SUNDRY NOTICES AND REPORTS ON WELLS

8. Well Name and No.
Python 3 Federal # 5

- ☒ Change of Plans
☐ New Construction
☐ Non-Routine Fracturing
☐ Water Shut-Off
☐ Conversion to Injection
☐ Dispose Water

EXHIBIT B
DRILLING RIG LAYOUT
NEARBURG PRODUCING COMPANY
Python 3 Federal # 5
SCALE 1" = 50'

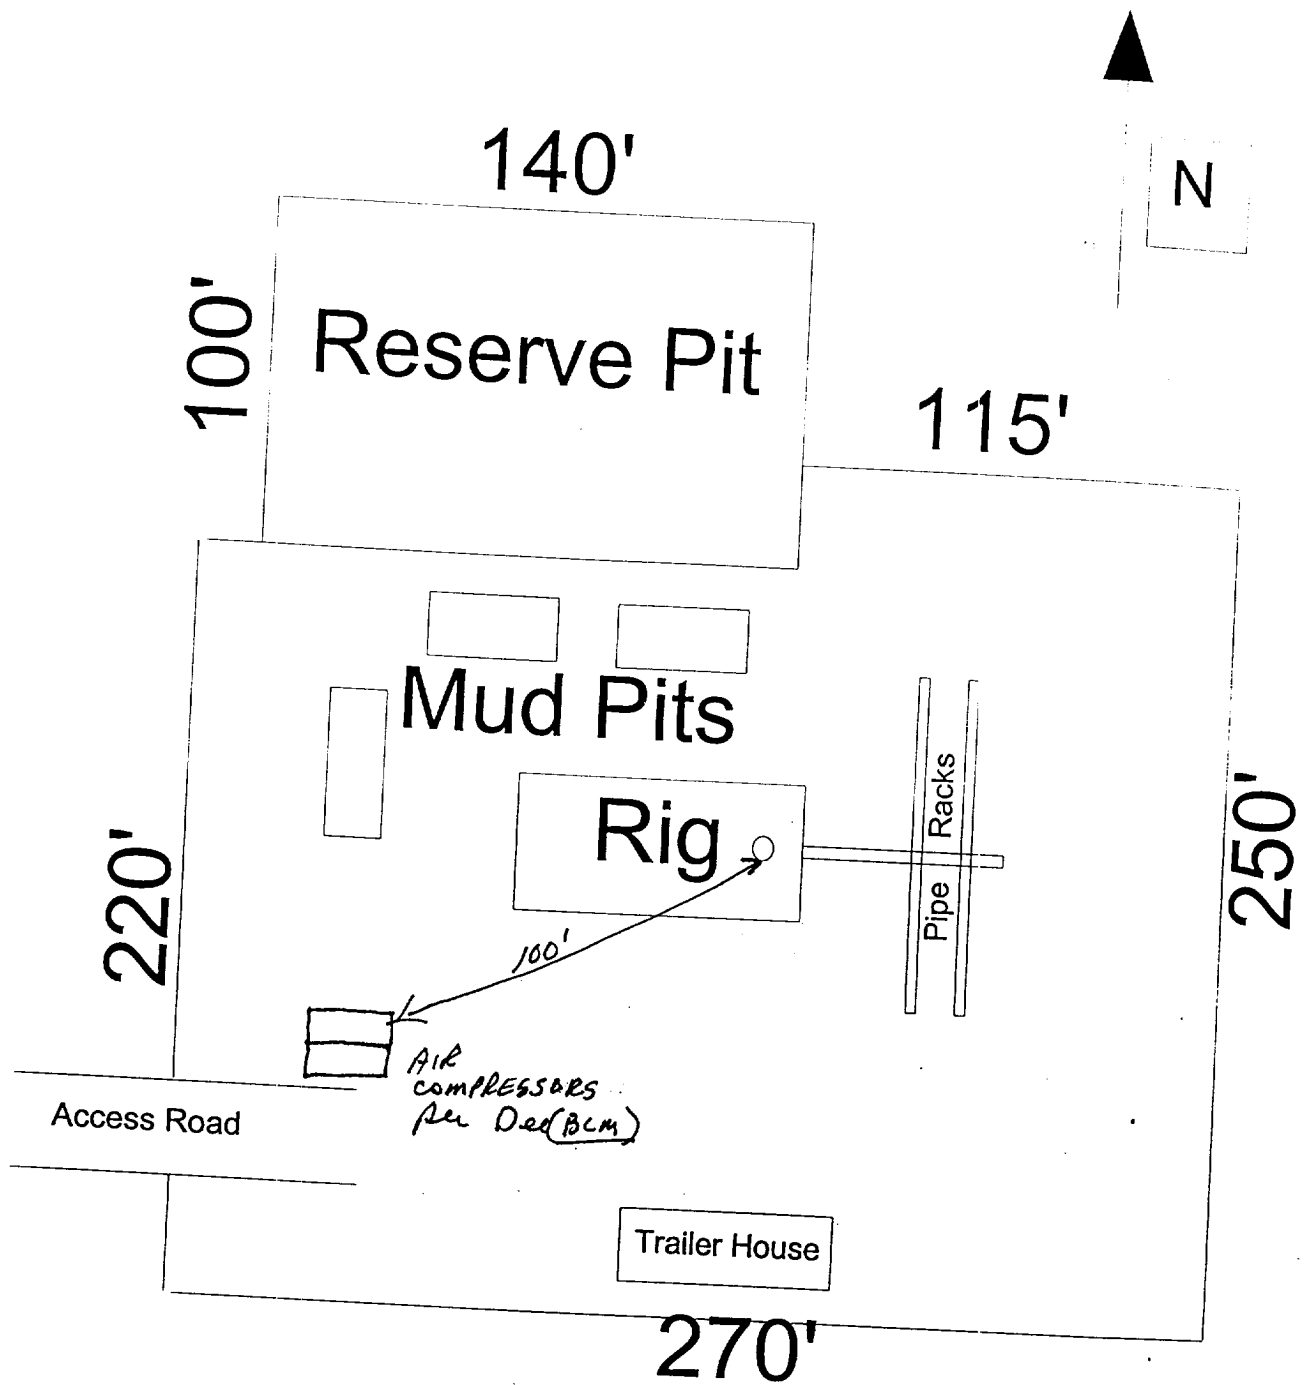
1. We will install and maintain a properly functioning rotating head.
2. Air compressor will be 100' from the well bore in the opposite direction from the blooie line as indicated on well plat.
3. Air compressor will have spark arresters or water cooled exhaust systems.
4. Ask for a variance on 100' blooie / flow line from well bore to 60' blooie / flow line from well bore approved by Les Babyak (BLM).
5. Automatic spark igniter mounted at end of blooie/flow line and functional.
6. Surface casing will be set at 1300' per requirments of the NMOCD.
